**Apsley Battery Energy Storage System – EIS Exhibition**

BCS has reviewed the Biodiversity Development Assessment Report (BDAR) for the project.

### Apsley Battery Energy Storage System – Environmental Impact Statement

Figure 2 – Native Vegetation Cover and Patch in the Biodiversity Development Assessment Report (BDAR) shows the Native Vegetation within 1500m of Subject Land.

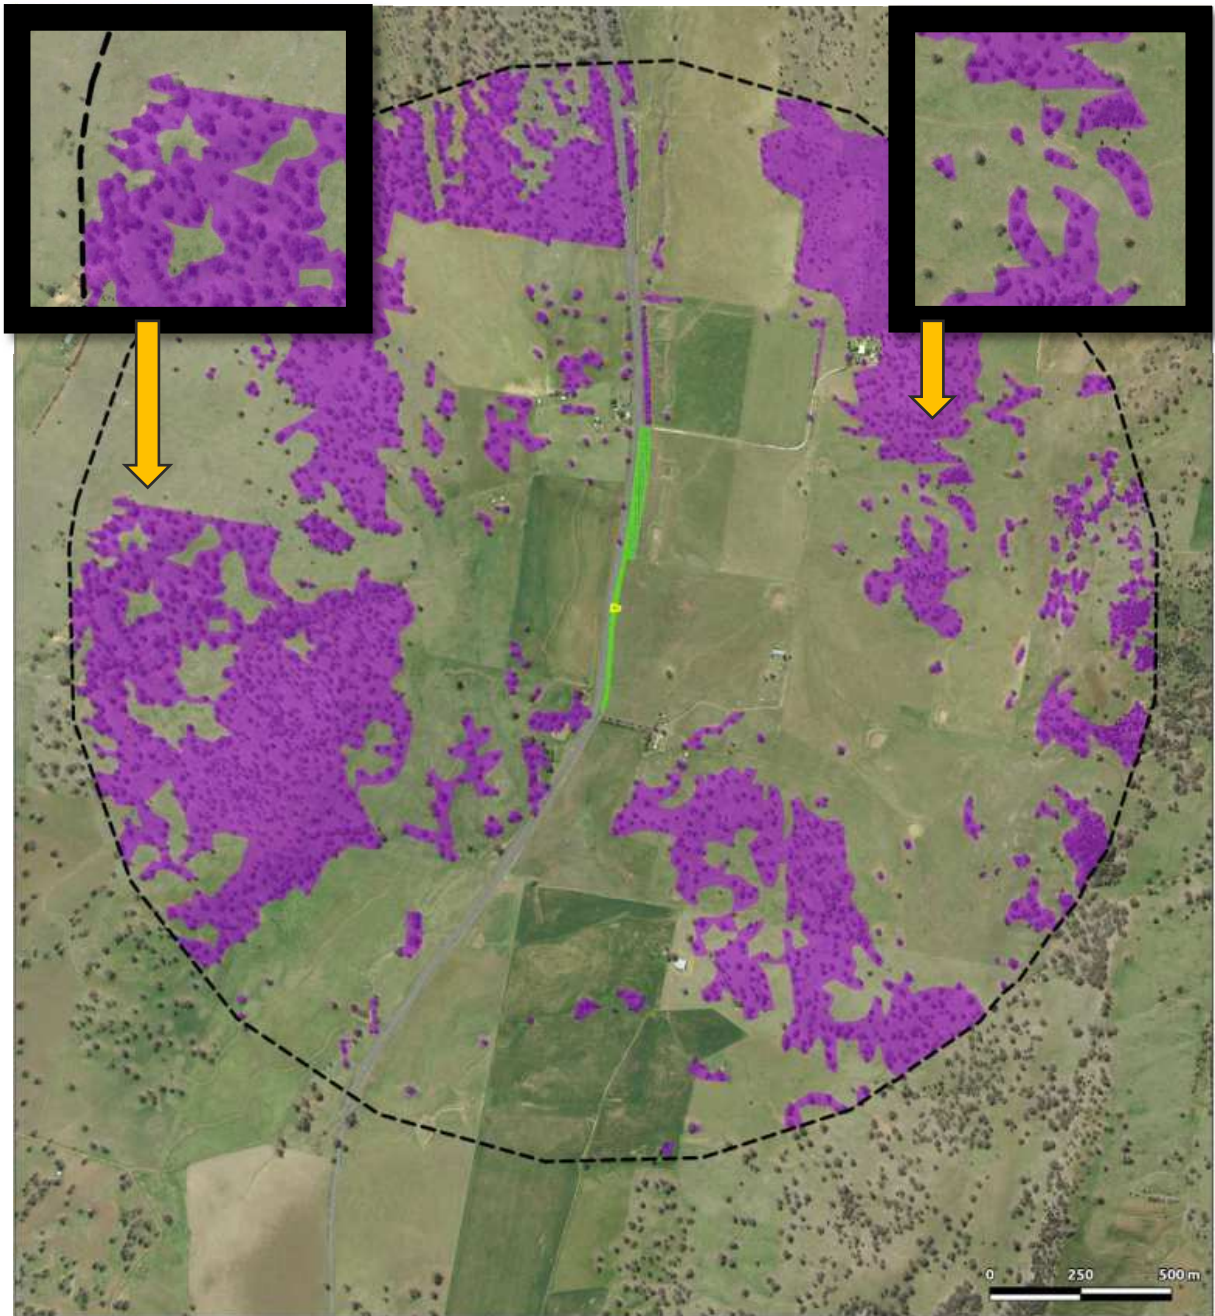
BCS notes that the native vegetation cover within the 1500m landscape buffer predominantly maps areas of dense woody vegetation as native vegetation (See Figure 1 below). The mapping also excludes some woody vegetation without explanation (See insert in top right-hand corner in Figure 1 below).

The assessor should undertake finer scale vegetation extent mapping and include all native vegetation (including scattered paddock trees), in accordance with the requirements set out within Section 3.2 of BAM 2020. Justification can be used to exclude areas that do not support any native vegetation.

The percentage of native vegetation cover in the assessment area may need to be revised. If areas of native vegetation extent are changed within the BDAR, this must also be made consistent within the Biodiversity Assessment Method Calculator (BAM-C).

- 1.1. Revise vegetation extent mapping to include all areas of native vegetation within mapping.
- 1.2. Revise percentage of native vegetation cover class to be consistent with the mapping. A subsequent revision of the candidate threatened species list generated for the project may occur.
